Project name	IWP4		
Design note title	126669/FO/2020 - Planning Condition 4 - Surface Water Drainage		
Document reference	10042-HYD-XX-XX-TN-D-0001		
Author	Neil Byrne		
Revision	P03		
Date	29 January 2021	Approved	✓

This document addresses the following planning condition (126669/FO/2020 - Planning Condition 4):

IW4-HYD-XX-XX-DR-D-0200

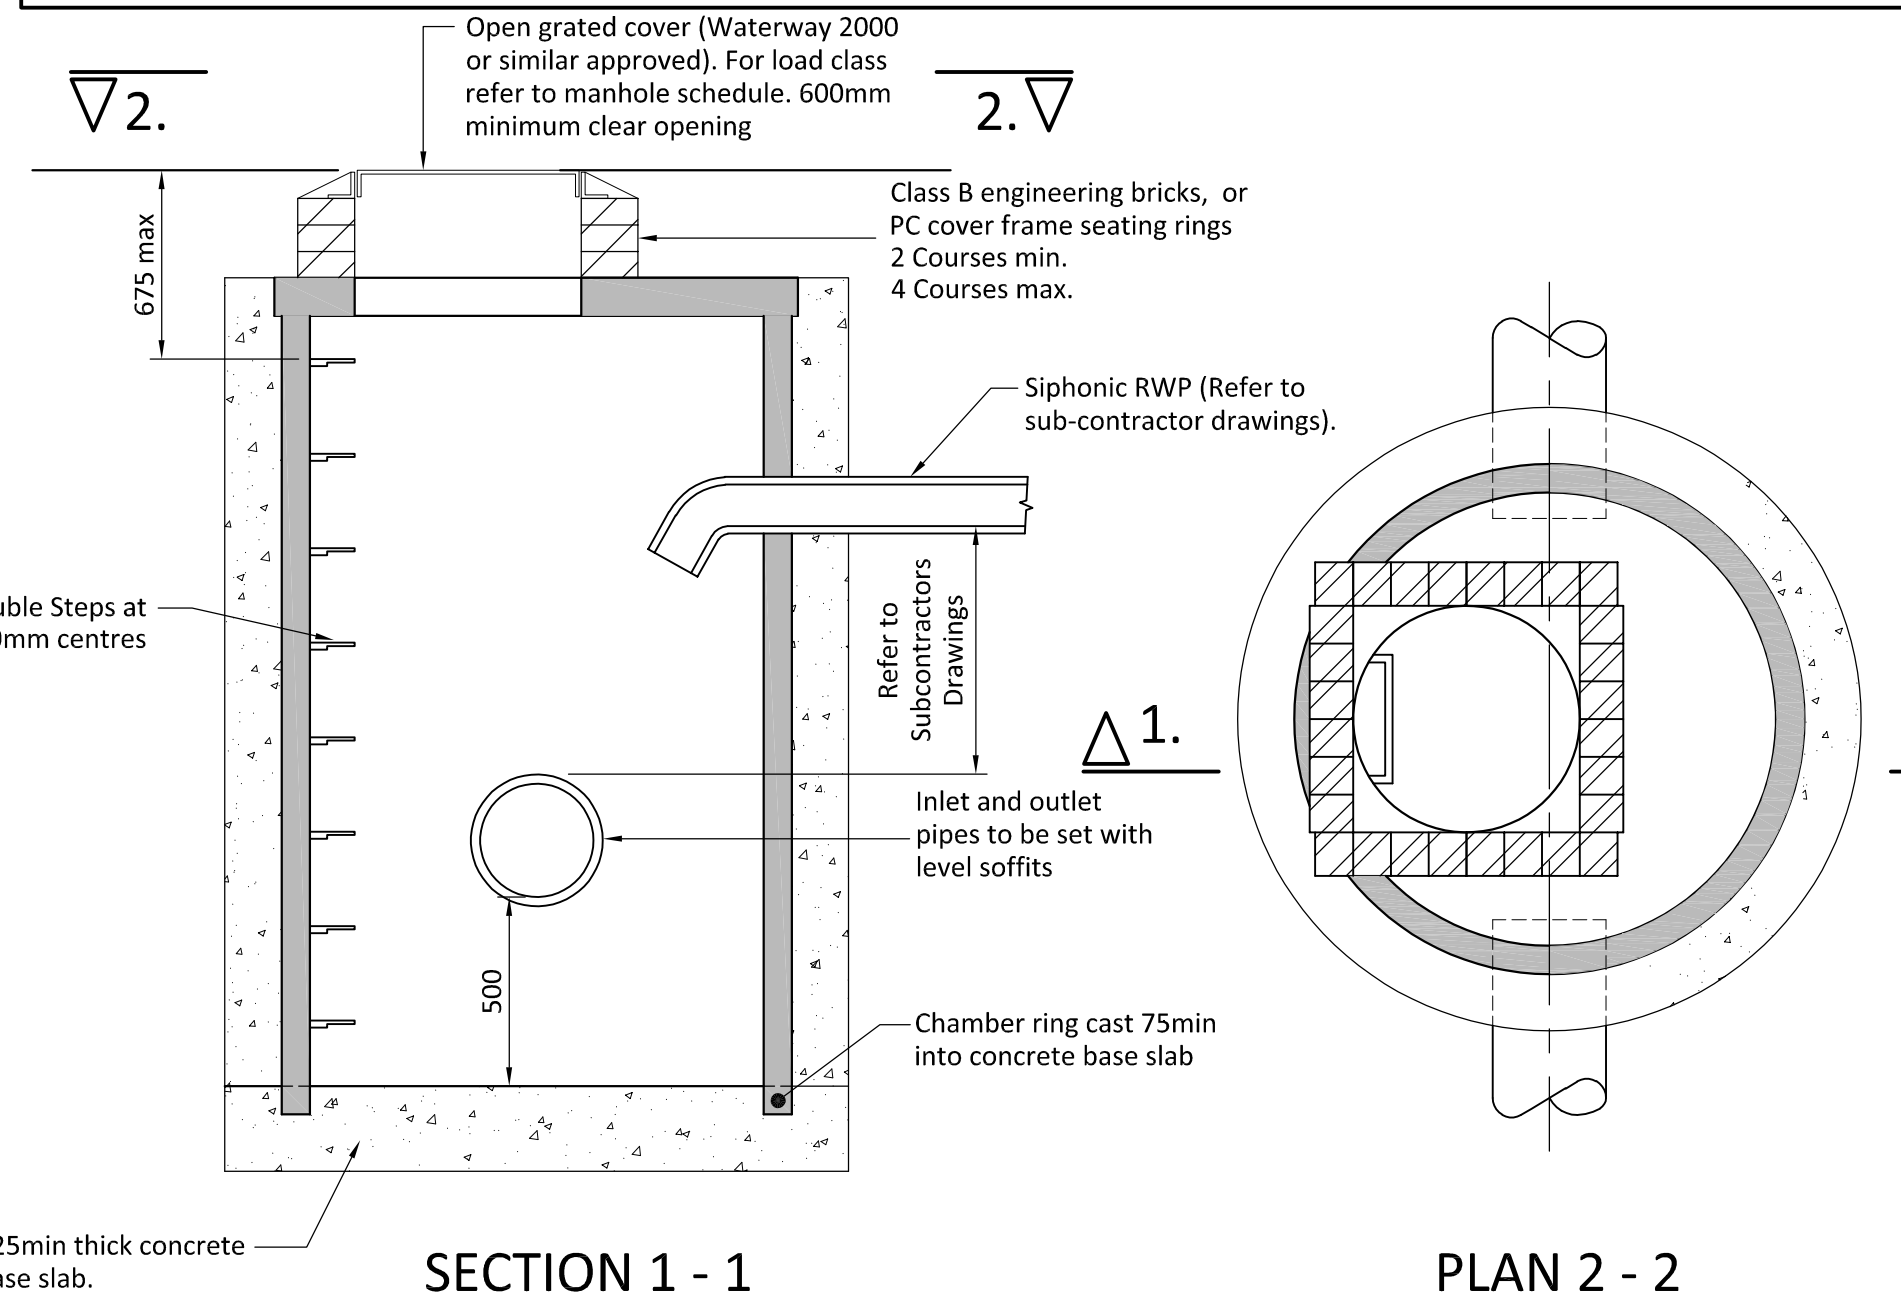
5.1.2 FFLS should be set 150mm above MH cover levels, please update drainage layout IW4-HYD-XX-XX-DR-D-0200 in the Technical Note.

As there is little available space around the building and there is no 150mm step down from internal to external level it has not been possible to accommodate this. To compensate we have provided extra capacity in the SW drainage system - the calculations show that the highest water level is 45.33m and the lower FFL is 45.80m, so there is over 450mm 'freeboard' designed within the manholes. We believe that is a suitable alternative. Note that this was already included within the design and is a point of clarification only.
